CITY OF ALBUQUERQUE

RE: **Superior Carwash**
10900 Unser NW
Grading and Drainage Plan
Engineer's Stamp Date: 3/23/18
Drainage File: A11D018

Based on the information provided in your submittal received 3/26/18, the grading and drainage plan cannot be approved until the following are addressed:

ENGINEER'S SEAL DAVID SOULE NEW MEXICO 14522 REGISTERED PROFESSIONAL ENGINEER	SUPERIOR CAR WASH GRADING AND DRAINAGE PLAN <i>Rio Grande Engineering</i> 1606 CENTRAL AVENUE SE SUITE 201 ALBUQUERQUE, NM 87106 (505) 872-0399	DRAWN BY WCWJ DATE 3-22-18 21878-LAYOUT-3-22-18 SHEET # JOB # 21878
--	---	--

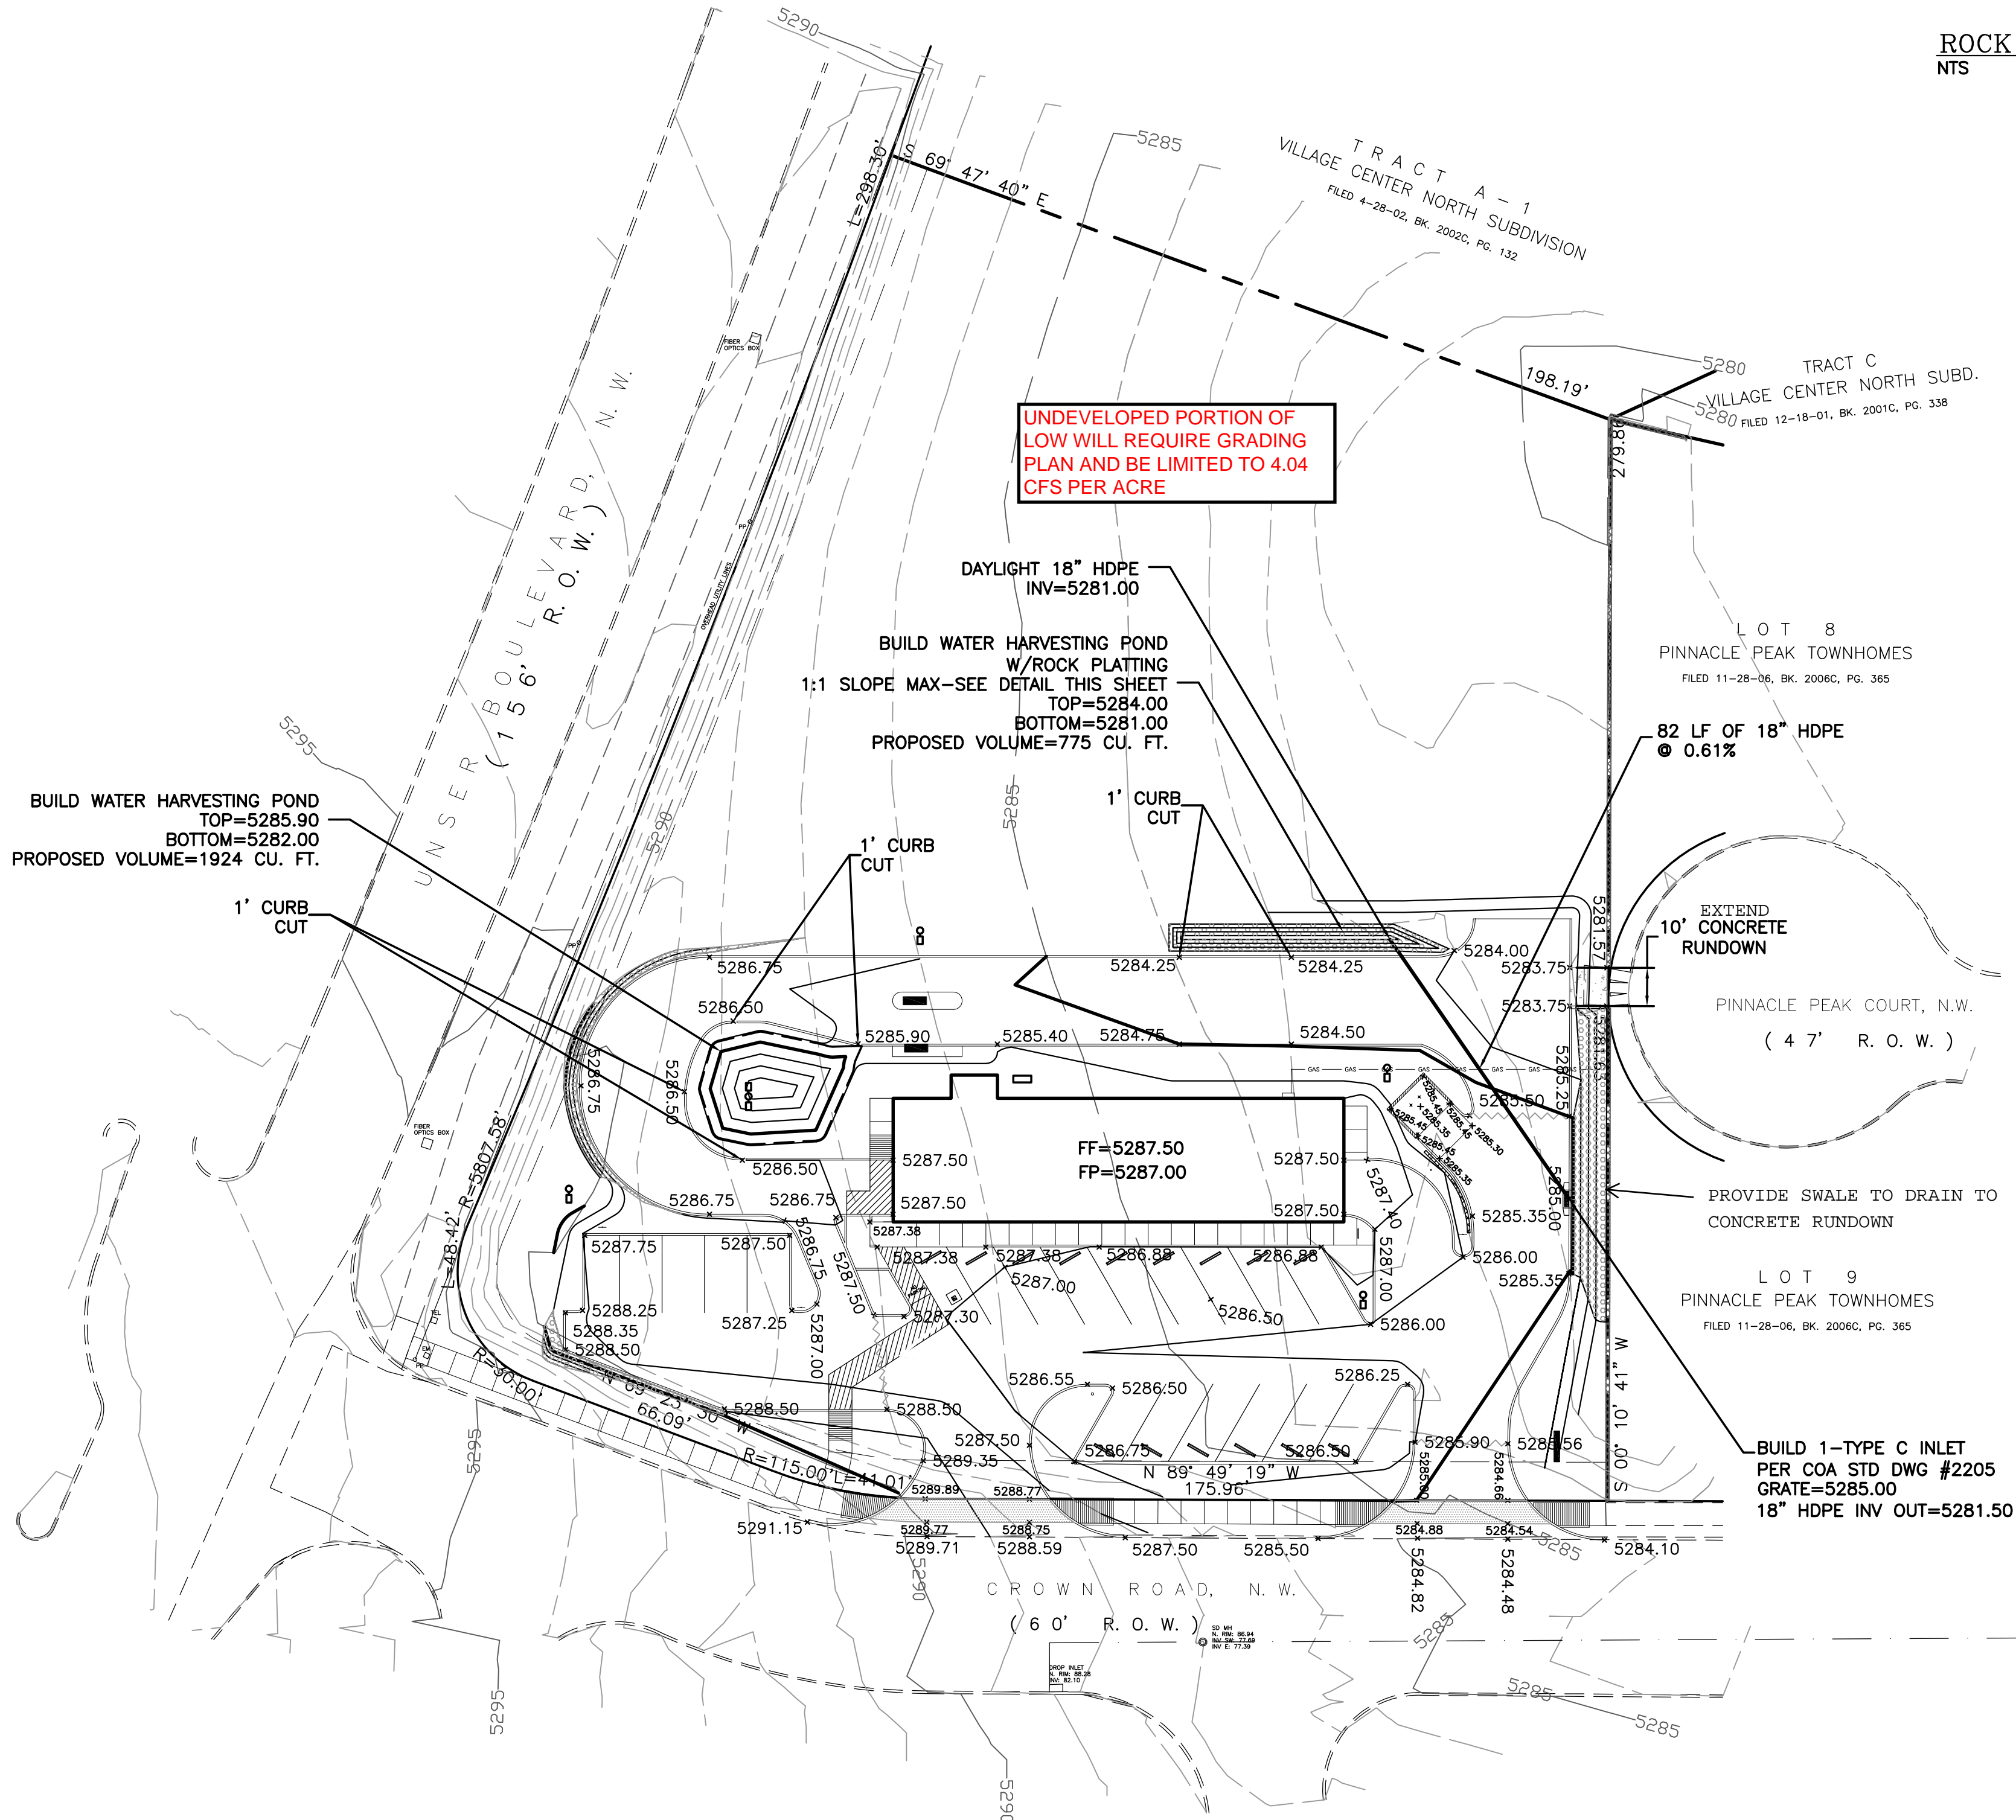
1. If only seeking Site Plan for Building Permit approval at this time, label the grading plan "Conceptual, Not For Construction" or similar and address the SPBP comments. If seeking SPBP and Building Permit simultaneously, forgo the conceptual markings and address all SPBP and Building Permit comments.
2. Basin A seems to be a landscaping strip with very little impervious, but is claimed as 92% D; please clarify/correct.
3. Basin D appears to be wholly contained onsite and shouldn't be counted against the site's allowable discharge, therefore reducing the site discharge from 3.85cfs to 2.93cfs.

4. Add note on the plan that "No work shall be performed in the public ROW without an approved Work Order."
5. Payment of the Fee in Lieu for the required first flush volume must be made. This appears to be Basin B1, Basin B2, Basin A, and a portion of Basin E, as described in the drainage report hydrology. Once Basin A is corrected, a treasury deposit slip can be generated.
6. A Private Facility Drainage Covenant is required for the stormwater quality ponds. The original notarized form, exhibit A (legible on 8.5x11 paper), and recording fee (\$25,

7. This project requires an ESC Plan, submitted to the Stormwater Quality Engineer (Curtis Cherne PE, ccherne@cabq.gov or 924-3420).
